Re: Residential-Business Planned Development
No. 368-Cityfront Center (DuSable Park)

Re: Cityfront Center - Planned
Development No. 368
Amendment to Section I Internal Design
Standards (Pedestrian Circulation Plan)

Re: Residential-Business Planned
Development No. 368 Cityfront Center

CITYFRONT CENTER PLANNED DEVELOPMENT
SITE DEVELOPMENT STANDARDS MODIFICATIONS

PEDESTRIAN CIRCULATION PLAN
FIGURE 5

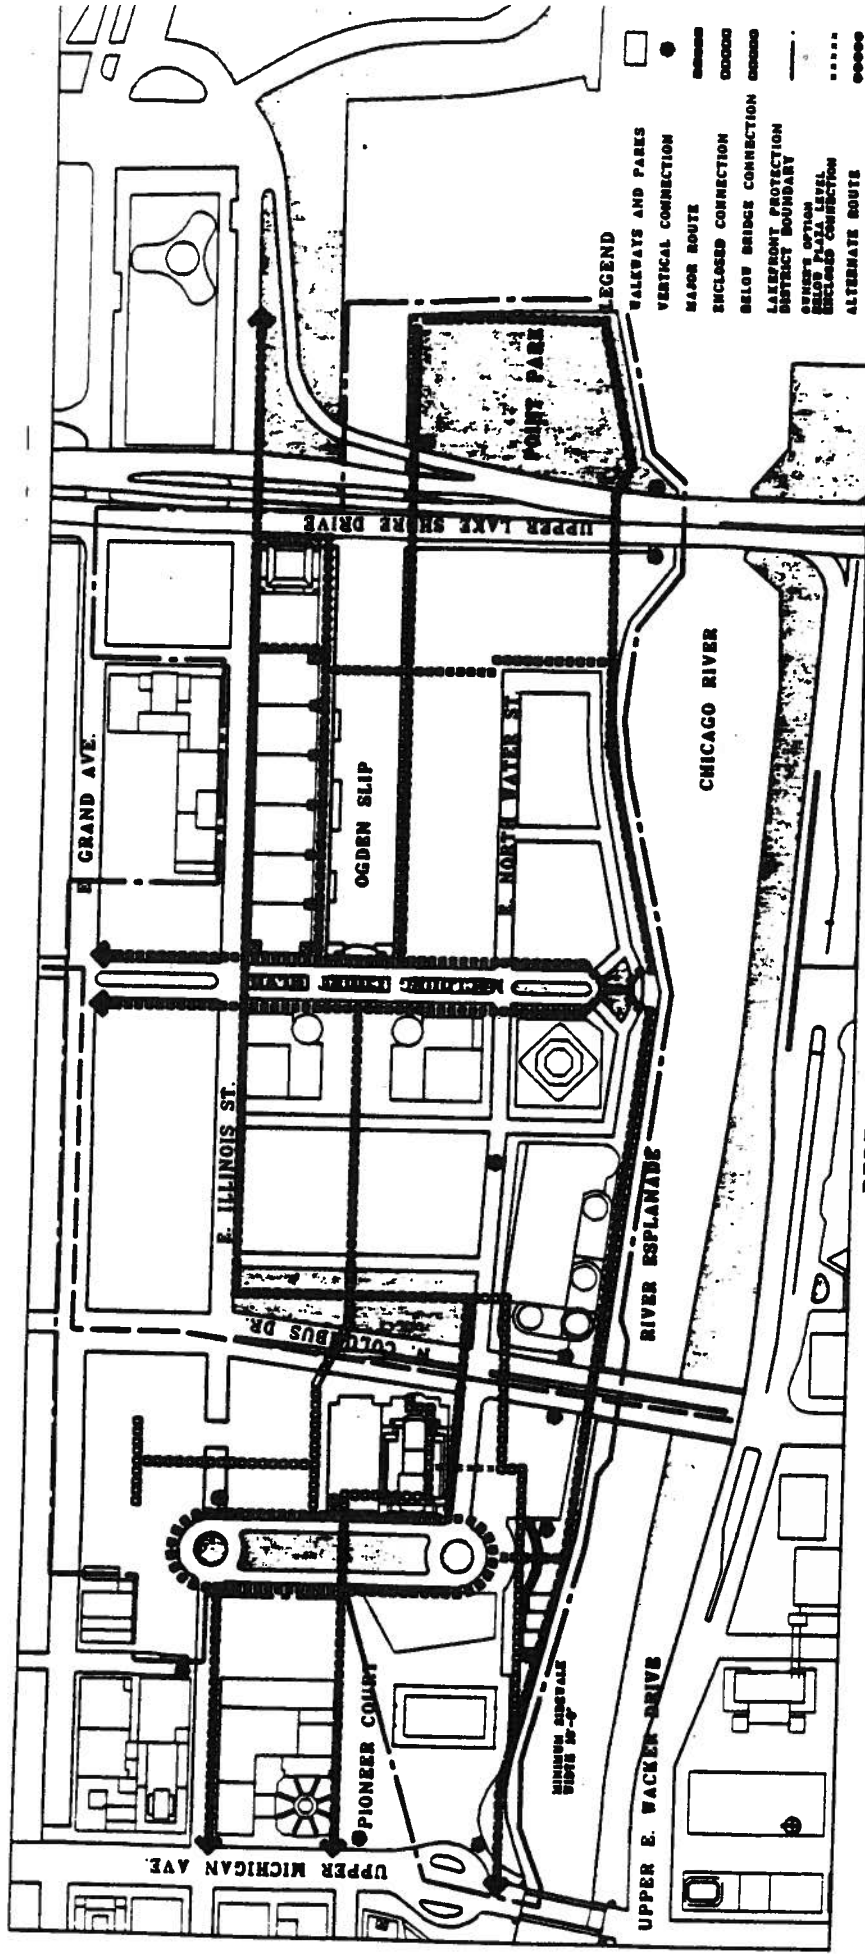
Specifically, you have requested a substitution of the Pedestrian Circulation Plan (Figure 5) as revised, dated August 6, 1992, with a revised plan dated August 19, 1996. The revised plan reflects your request to eliminate required pedway connections between the existing NBC Building and future development sites to the north and south. Since the NBC Building was designed and constructed with parking at the concourse level, pedestrian concourse linkages to adjacent parcels at that level would not be feasible. A vertical connection from the concourse level up to NBC's lobby would also be difficult because of the existing design of the NBC building. The revised plan therefore eliminates the link to the north and includes an "optional" connection from the NBC Building to the south. The revised map also depicts a new east-west street level pedestrian walkway through the NBC Building.

The Section I Internal Design Standards require that any changes to the Standards be approved by all the initiating parties (Chicago Dock & Canal Trust, Equitable and the Chicago Department of Planning and Development). The Department has received a copy of a letter from Chicago Dock & Canal approving the requested pedway plan revisions. Based on the aforementioned difficulties in implementing the 1992 Pedestrian Circulation Plan as it relates to the existing NBC Building, and conditioned on Equitable's continuing commitment to complete the remaining portions of the pedway system for which it is responsible, I therefore approve the requested revisions to the 1992 Pedestrian Circulation Plan.
